SUNDRY NOTICES AND REPORTS ON WELLS (DO NOT USE THIS FORM FOR PROPOSALS TO DRILL OR TO DEEPEN OR PLUG BACK TO A DIFFERENT RESERVOIR. USE "APPLICATION FOR PERMIT" (FORM C-101) FOR SUCH PROPOSALS.)		WELL API NO. 30-025-23595

2. Name of Operator ENDEAVOR ENERGY RESOURCES, LP		6. State Oil & Gas Lease No. K-3290
3. Address of Operator 110 NORTH MARIENFELD, SUITE 200, MIDLAND, TX 79701		7. Lease Name or Unit Agreement Name BAUM "E" STATE

**WELLBORE DIAGRAM
BAUM "E" STATE #1**

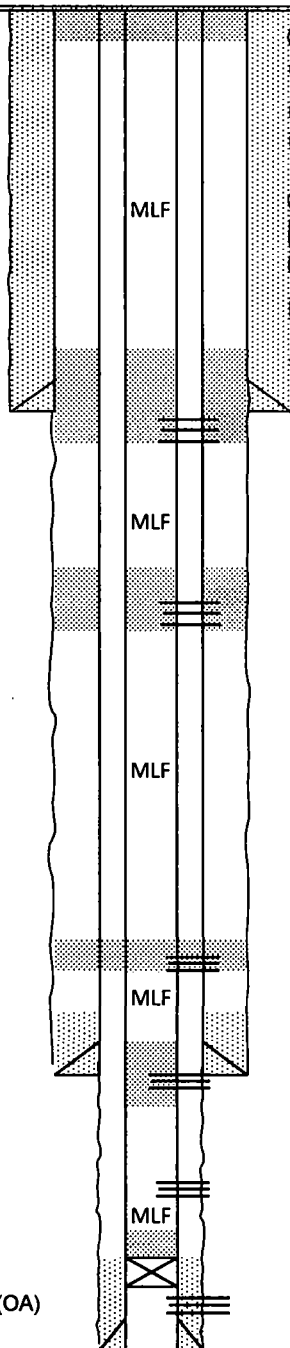
11. ~~SPOT 10SX OF CLASS "C" CEMENT FROM 15' SURFACE. (SURFACE)~~ *PT 50 SX CLASS C 150' CIR*
 12. CUTOFF WELLHEAD, ANCHORS 3' BELOW SURFACE AND INSTALL DRYHOLE MARKER. TURN OVER FOR TO SURF IN & OUT

SPOT 10SX OF CEMENT FROM 15'-SURFACE.
 VERIFY CEMENT AT SURFACE.
